AIRWORTHINESS DIRECTIVE

Beechcraft 55, 58 and 95-55 (Baron) Series Aeroplanes

**AD/BEECH 55/98
Amdt 1**

Forward Elevator Cable

Figure 1 - Forward Elevator Control Cable - Adapted from Beechcraft Illustrated Parts Catalogue.

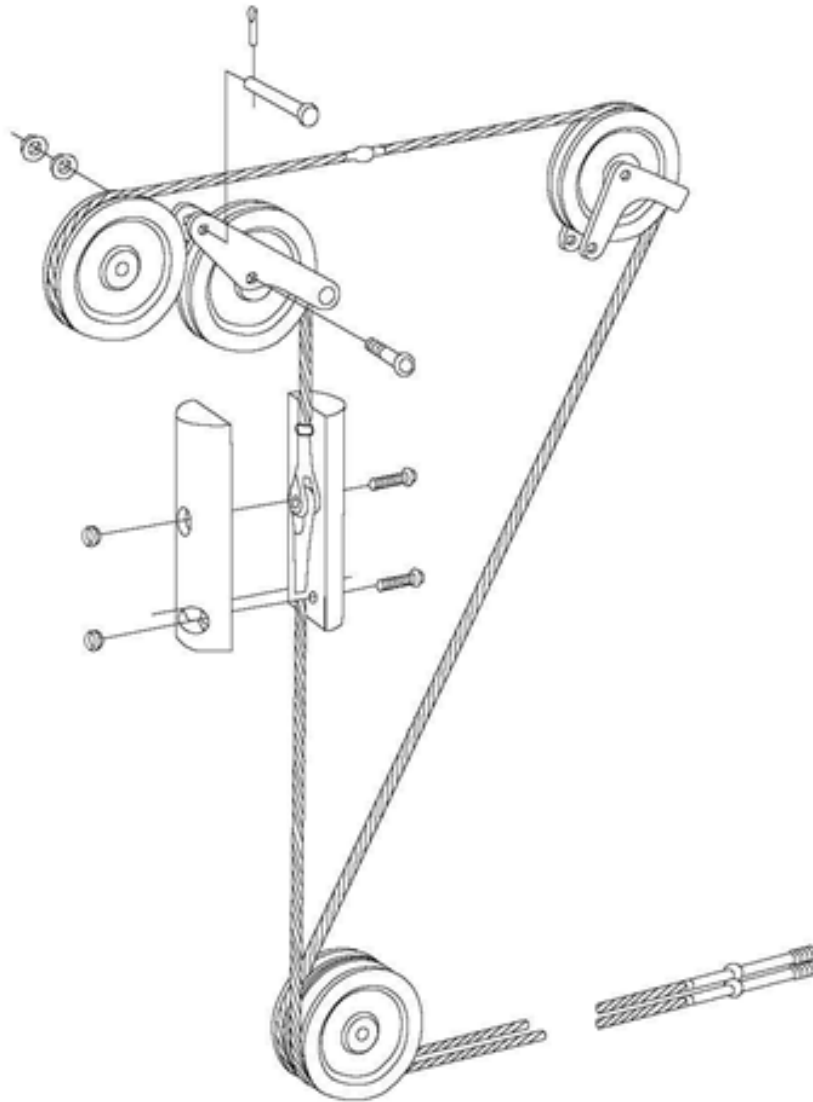
Applicability: All Beechcraft 55, 58 and 95-55 (Baron) aeroplanes fitted with the forward elevator control cable configuration as detailed in figure 1 of this AD.

This Amendment clarifies the applicability section of the AD by introducing additional criteria (Figure 1) to assist the registered operator in determining whether this AD is applicable to their aircraft.
